2. AMENDMENT/MODIFICATION NO. 0008		3. EFFECTIVE DATE 30-May-2003		4. REQUISITION/PURCHASE REQ. NO.		5. PROJECT NO.(If applicable) 0250570	
6. ISSUED BY USA ENGINEER DISTRICT, SEATTLE ATTN: CENWS-CT P.O. BOX 3755 SEATTLE WA 98124-3755		CODE DACA67		7. ADMINISTERED BY (If other than item 6) <div style="text-align: center; font-weight: bold;">See Item 6</div>

14. DESCRIPTION OF AMENDMENT/MODIFICATION (Organized by UCF section headings, including solicitation/contract subject matter where feasible.) BATTLE SIMULATION CENTER, FORT LEWIS WA - SEE CONTINUATION							
Except as provided herein, all terms and conditions of the document referenced in Item 9A or 10A, as heretofore changed, remains unchanged and in full force and effect.							
15A. NAME AND TITLE OF SIGNER (Type or print)				16A. NAME AND TITLE OF CONTRACTING OFFICER (Type or print)			
				TEL: _____ EMAIL: _____			
15B. CONTRACTOR/OFFEROR _____ (Signature of person authorized to sign)		15C. DATE SIGNED		16B. UNITED STATES OF AMERICA BY _____ (Signature of Contracting Officer)		16C. DATE SIGNED 30-May-2003

Rev. 00800 Drawing Revisions by Notation

DRAWING REVISIONS BY NOTATION

Wall Types, Sheets 155 and 156, Plates A-600 and A-601

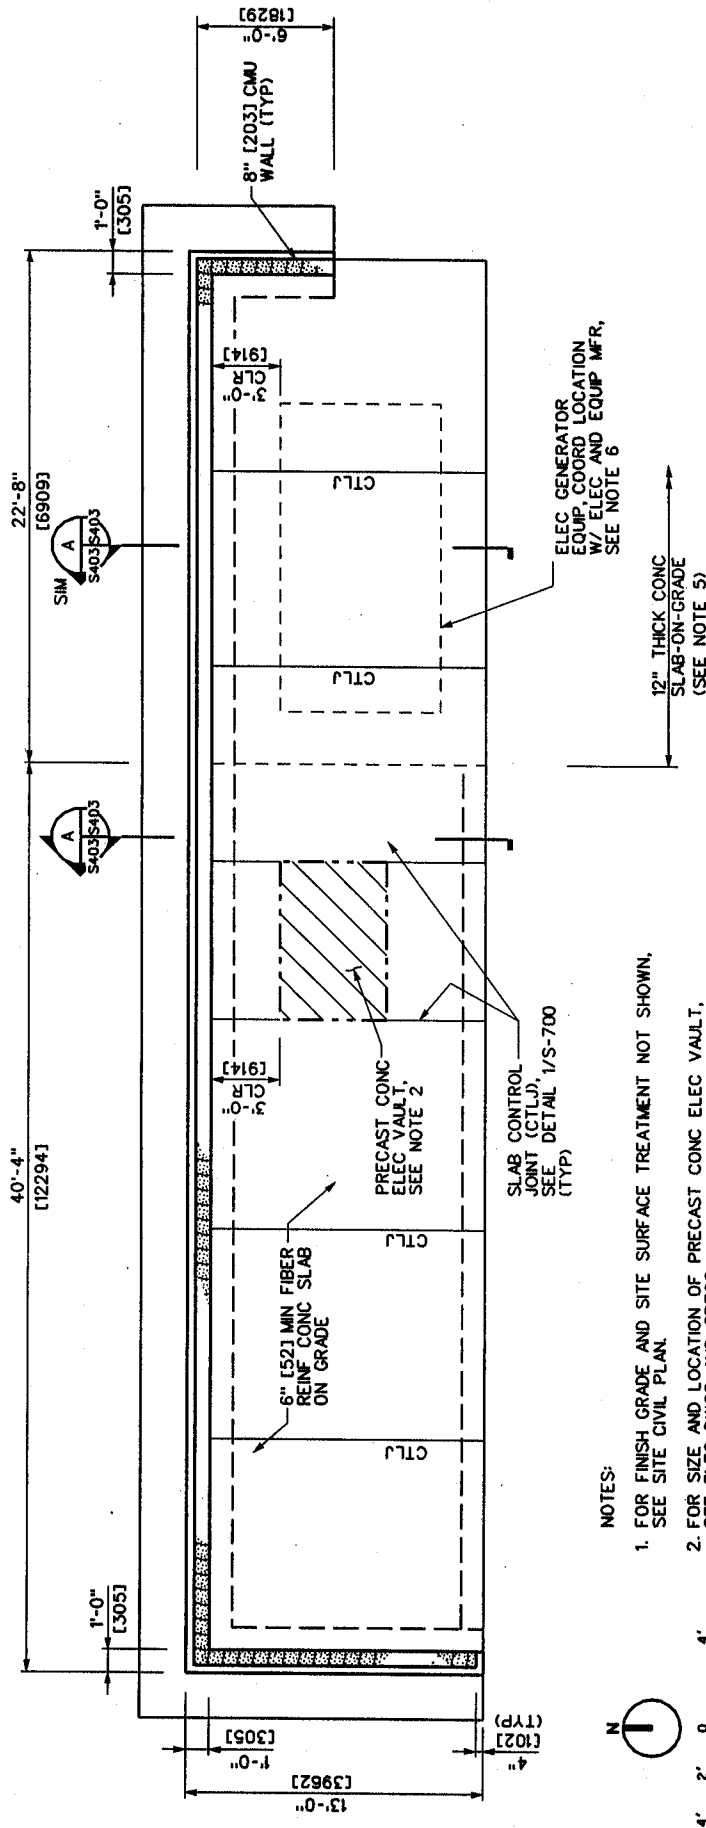
Revise Brick Size in wall types 1, 2, 5, 6, 15 and 16 to be 3-5/8" wide, 2-1/4" high and 8" long.

ELEC TRANSFORMER & GENERATOR ENCLOSURE PLAN
1/4"=1'-0"

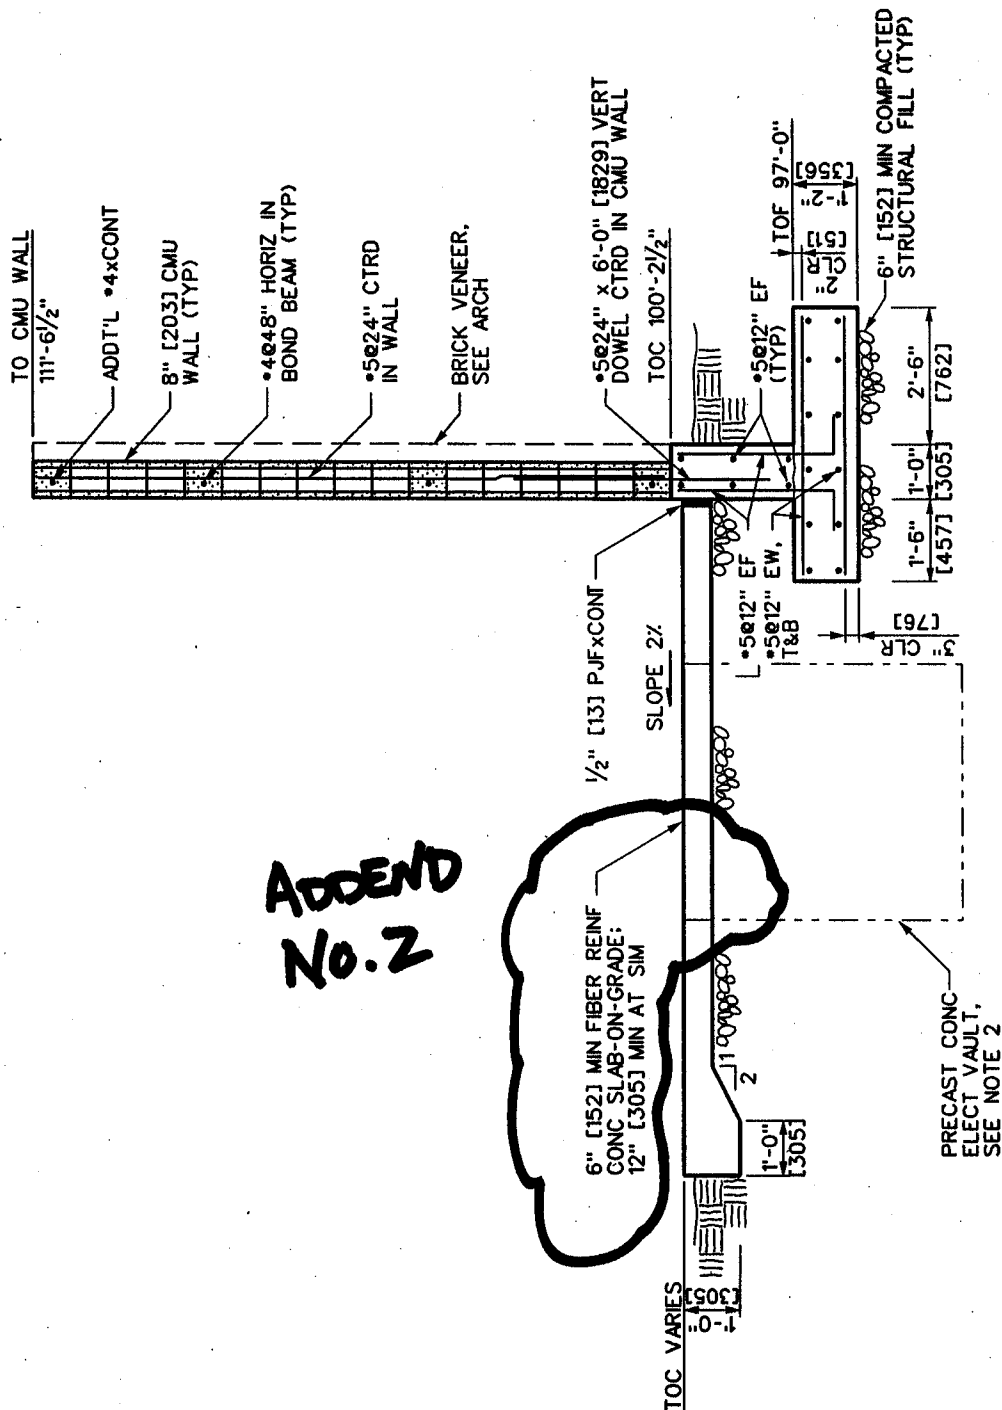
- (a) Modified and revised PLAN to accommodate new electrical generator equipment. Modifications included eastward extension of thickened concrete slab-on-grade, extension of enclosure wall system (CMU wall with exterior brick veneer), addition of Notes 5 & 6, and modification of the title to reflect the electrical generator equipment addition.
- (b) See attached sheet SD-1 (Elec Transformer & Generator Enclosure Plan, Plate S-403).

- (a) Modified slab thickness callout to reflect increased thickness at slab extension required for new electrical generator equipment.
- (b) See attached sheet SD-2 (Section A, Plate S-403).
